Addendum #4
Southern Wells Community Schools
Raiders Activity Center and Raider Dome Lockers

Date: April 03, 2026
Project: Southern Wells Community Schools Raiders Activity Center and Raider Dome Lockers
Project #: 25048
Pages: 1 of 5 (8-1/2x11) pages
Bid Dates: THURSDAY, April 9, 2026 at 4:00 pm (prevailing local time)

The original Specifications and Drawings dated April 03, 2026 for the project referenced above are amended as noted in this Addendum No. 4. Receipt of this Addendum and any subsequent Addenda must be acknowledged on the Bid Form. Items changed or added by this addendum are to take precedence over the items or descriptions of the work in the project manual and the drawings. Items not mentioned in this addendum are to remain as described in the original plans and specifications.

CAMERA LOCATIONS, SEE
ADDENDUM #4

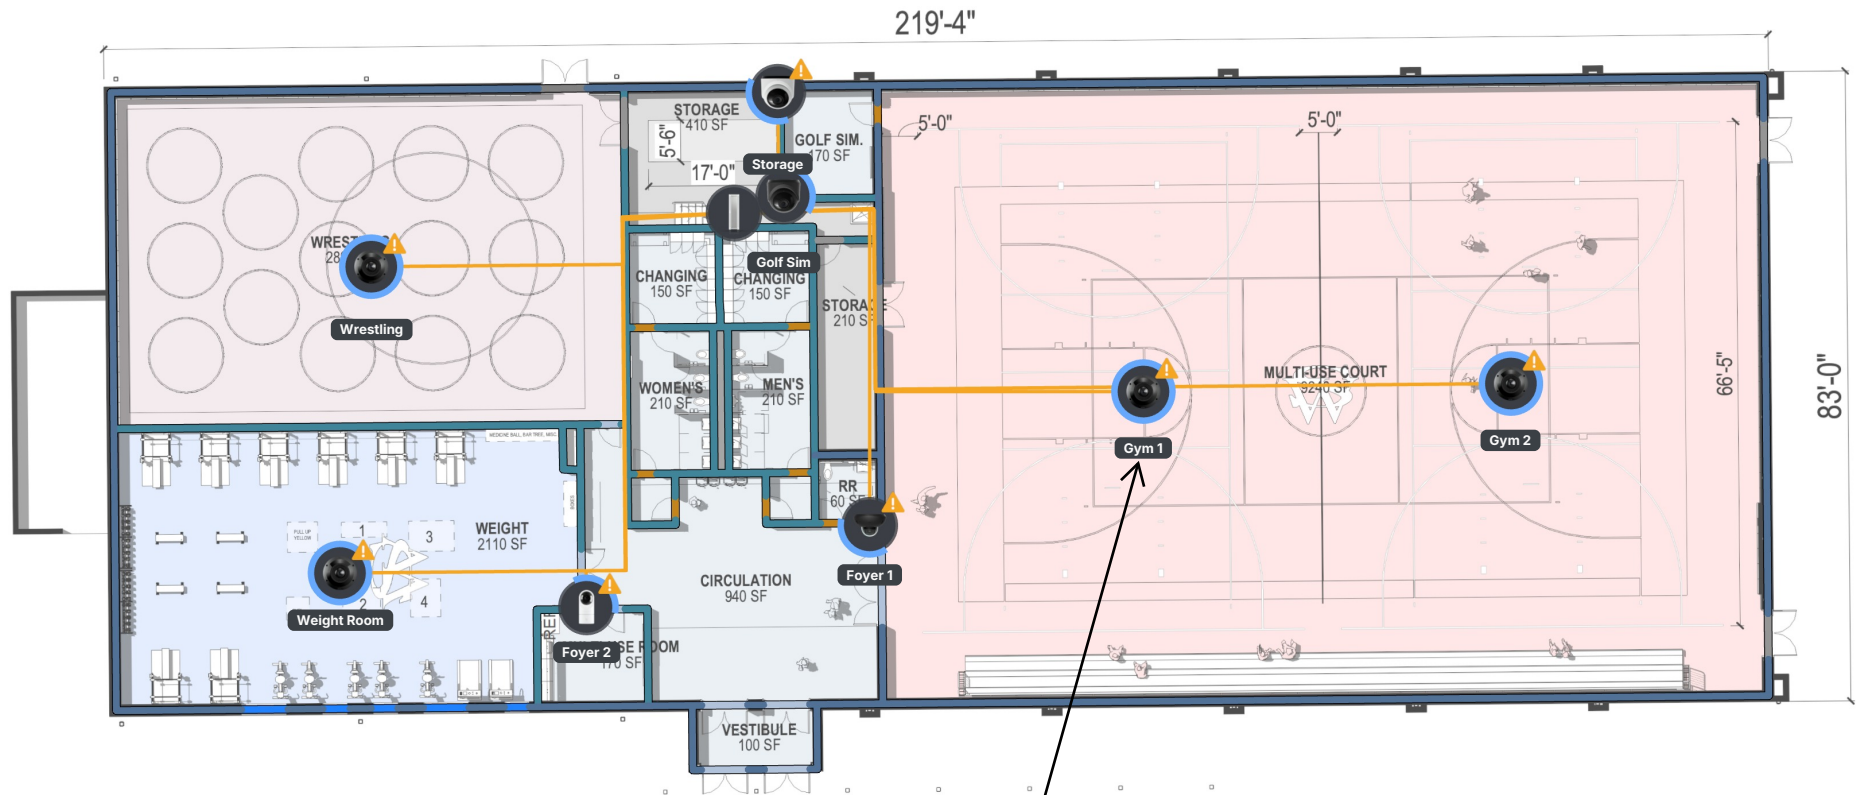
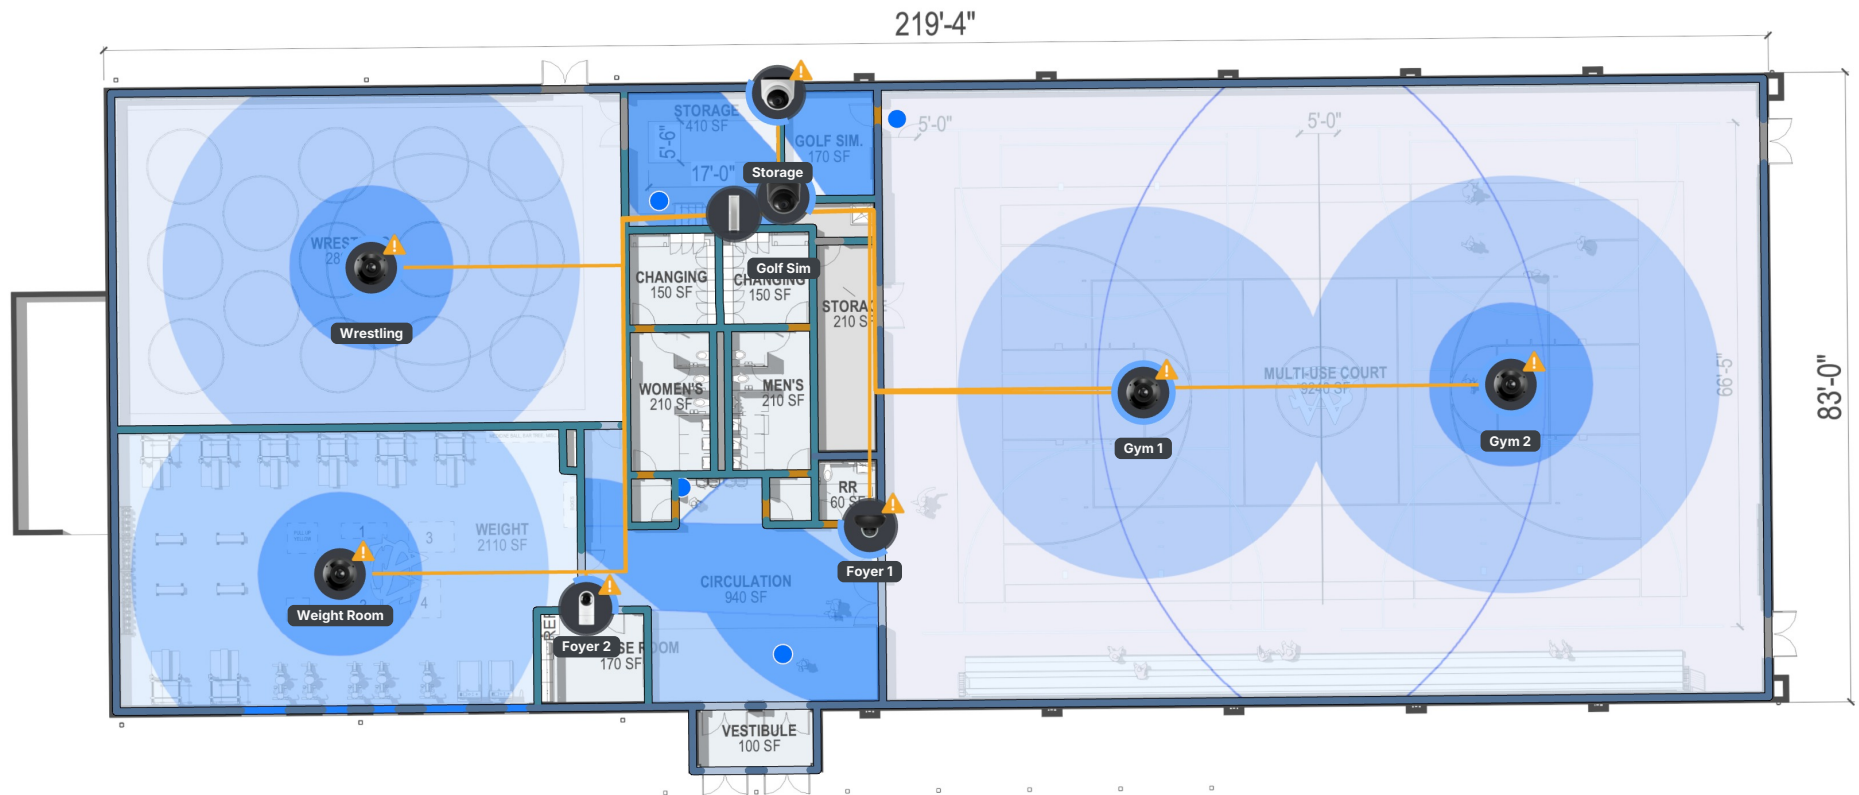
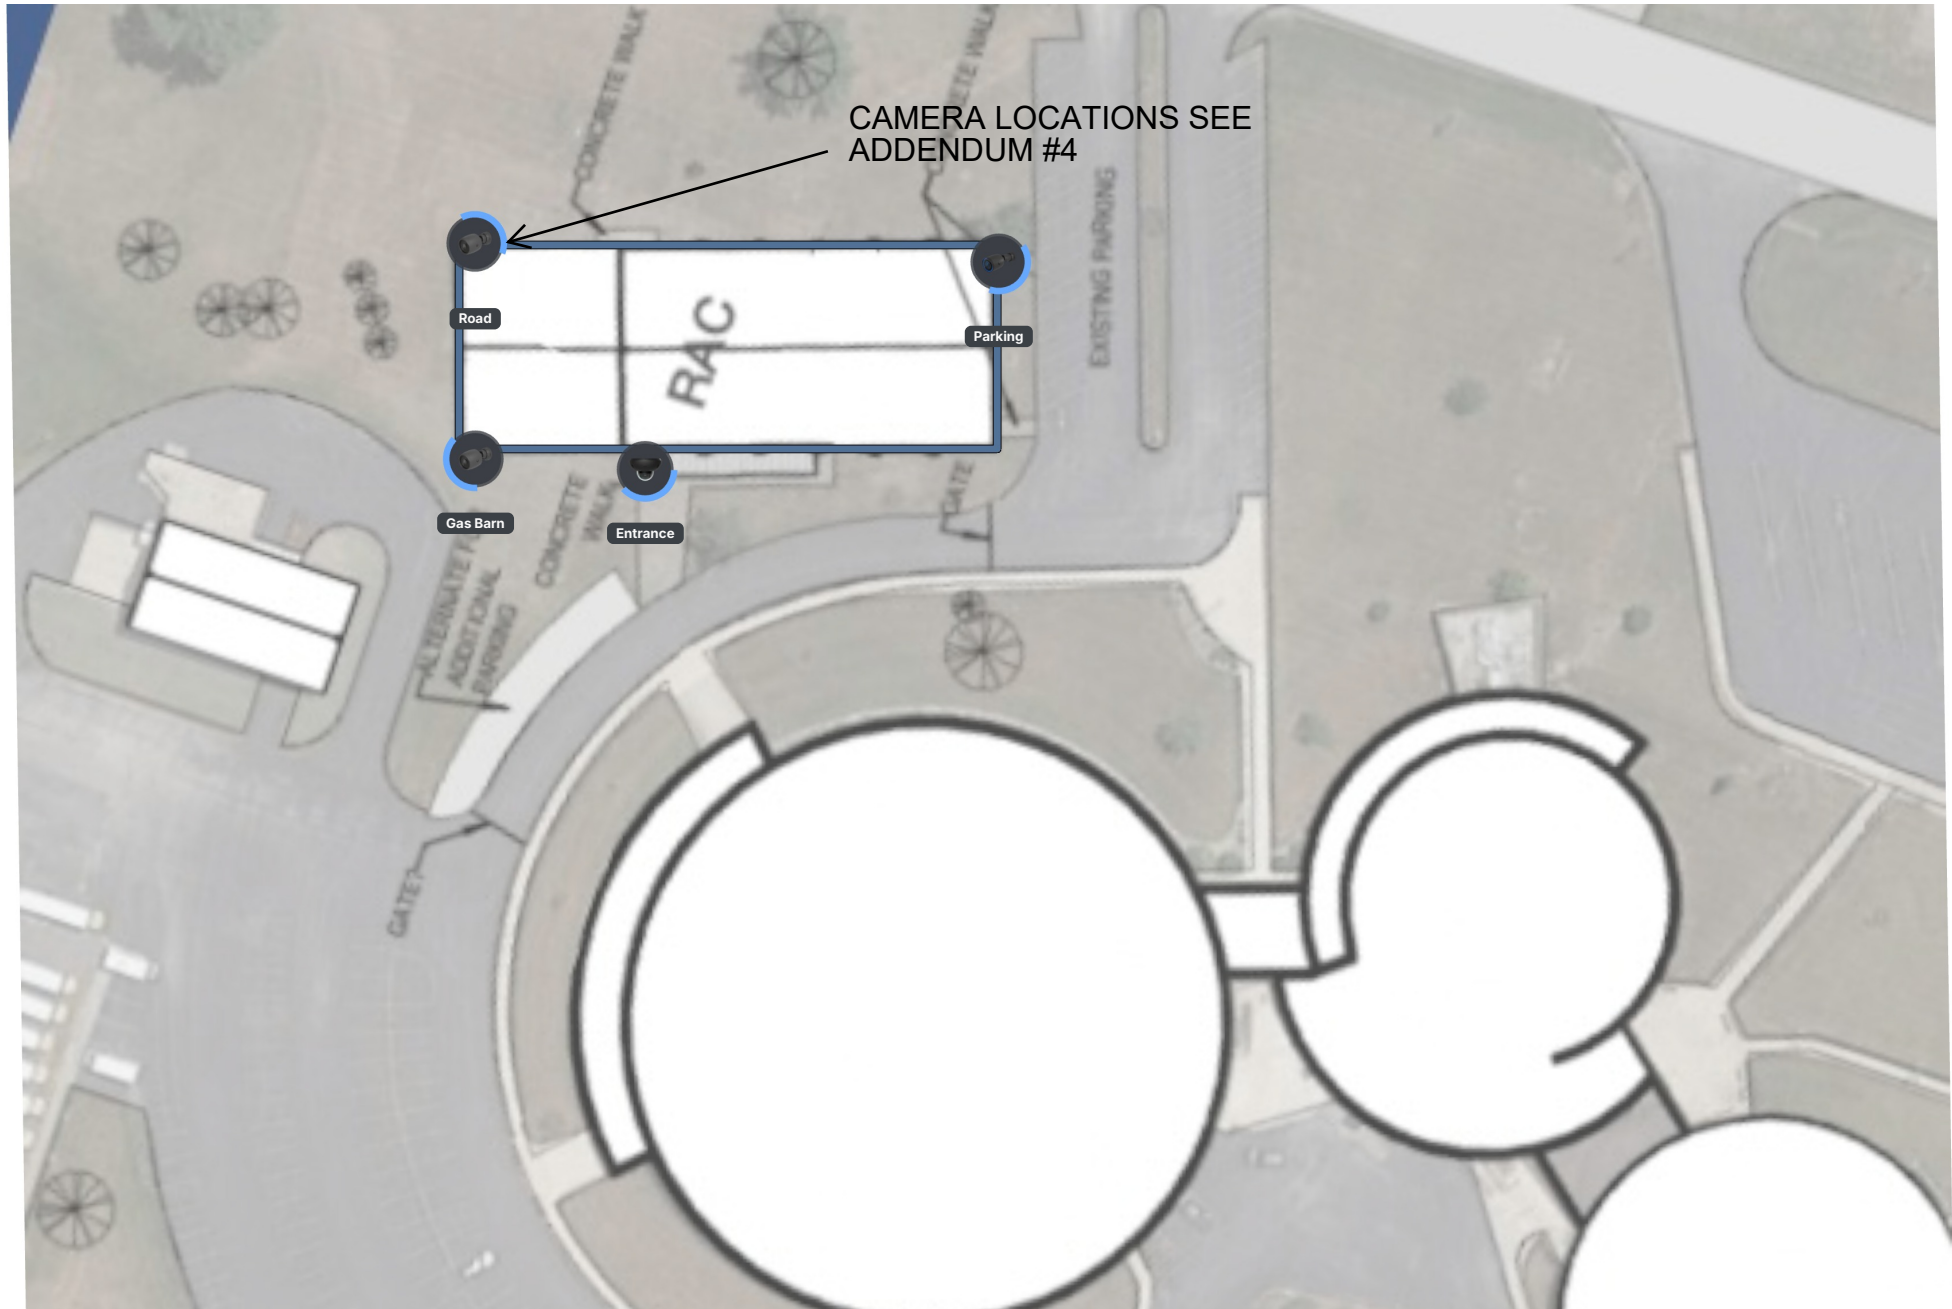
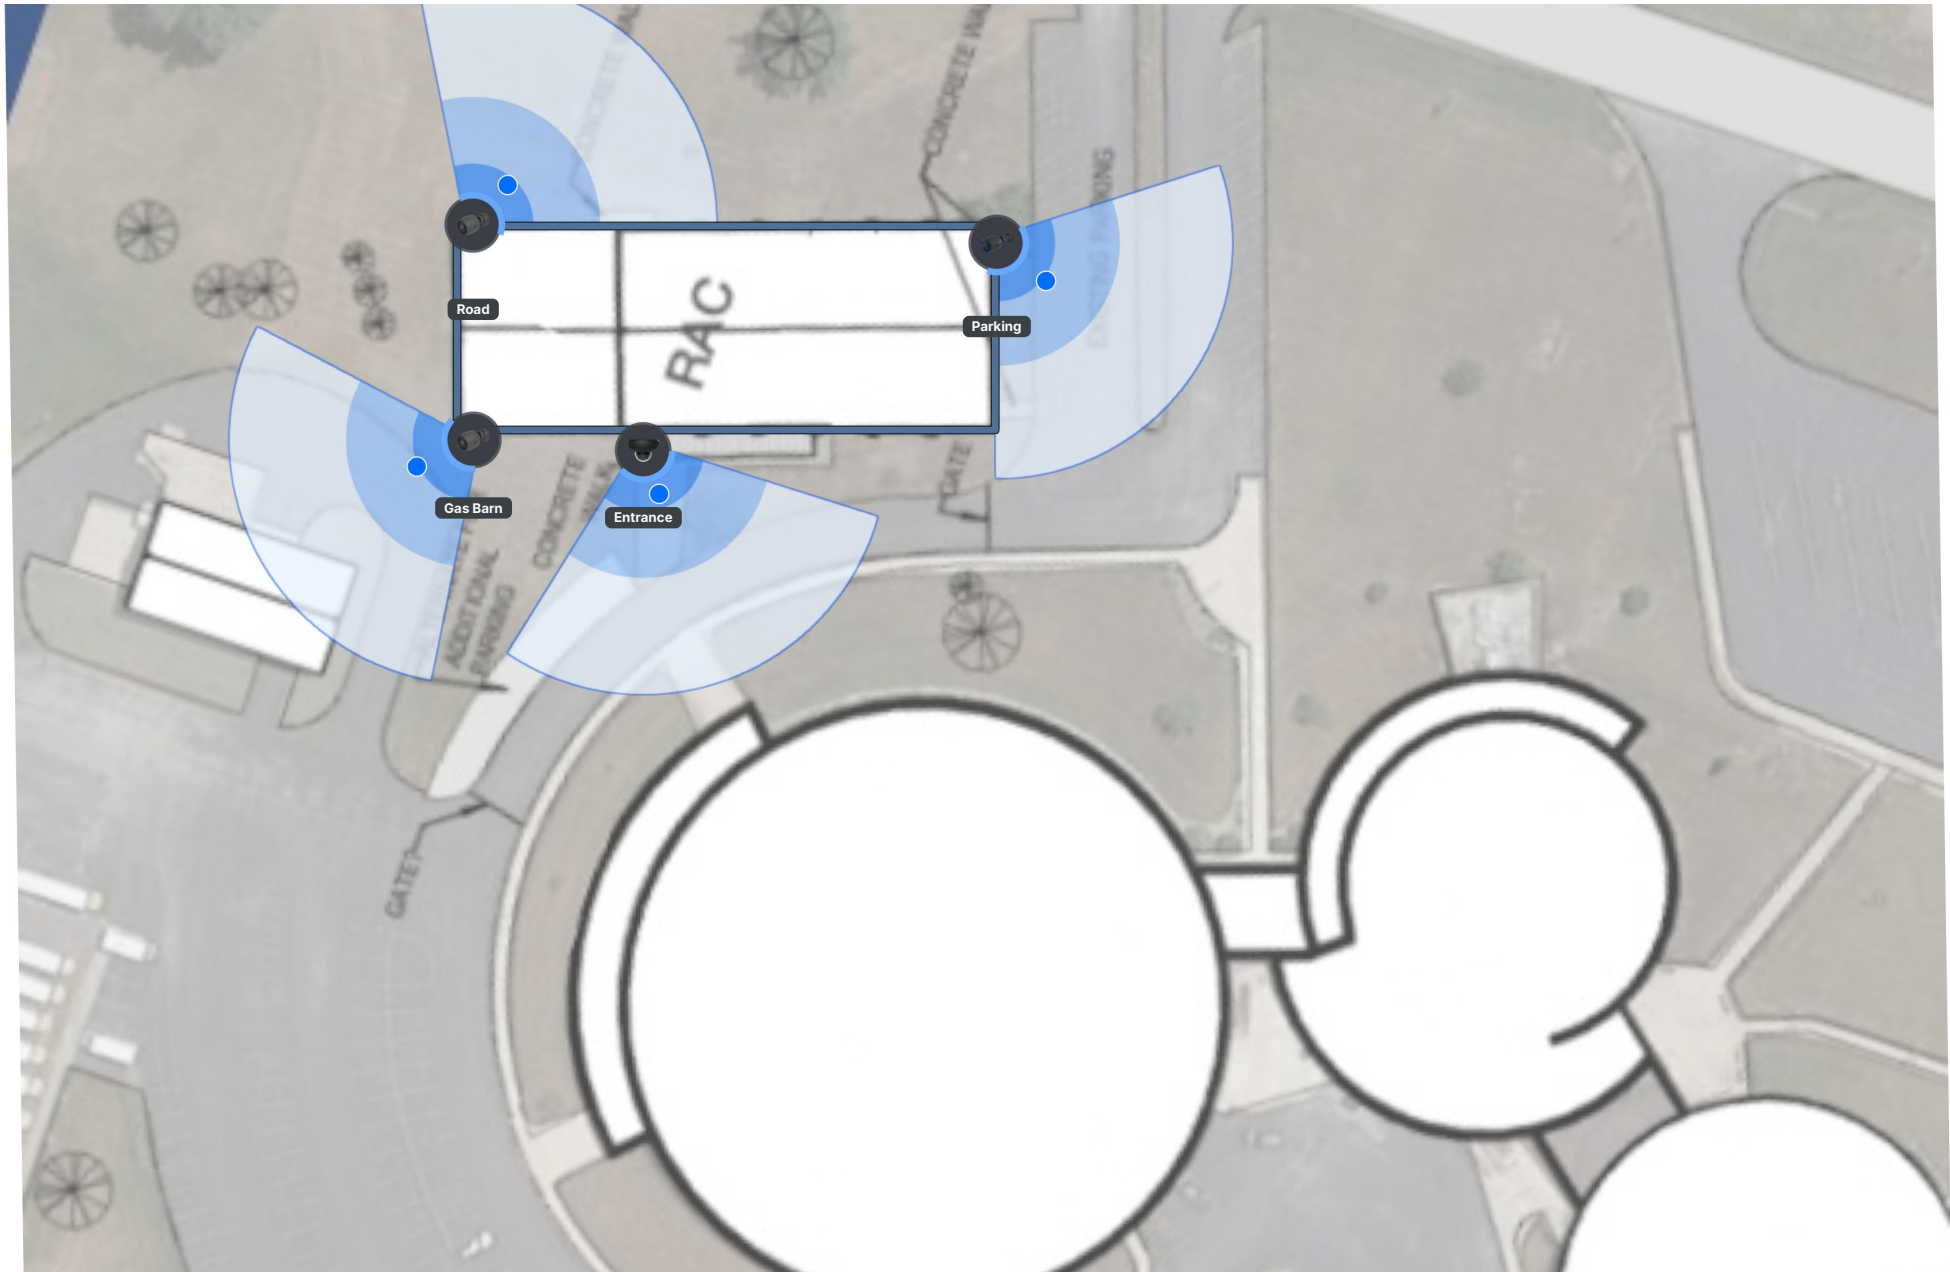
Owner. Cat 6 cable is to have conduit if it passes through a wall or ceiling. All other locations can be exposed, cable-tied up according to detail 10 / E1-2. All conduits passing through the firewall to have fire caulking. Camera locations will be updated on electrical plans in the For Construction Set.
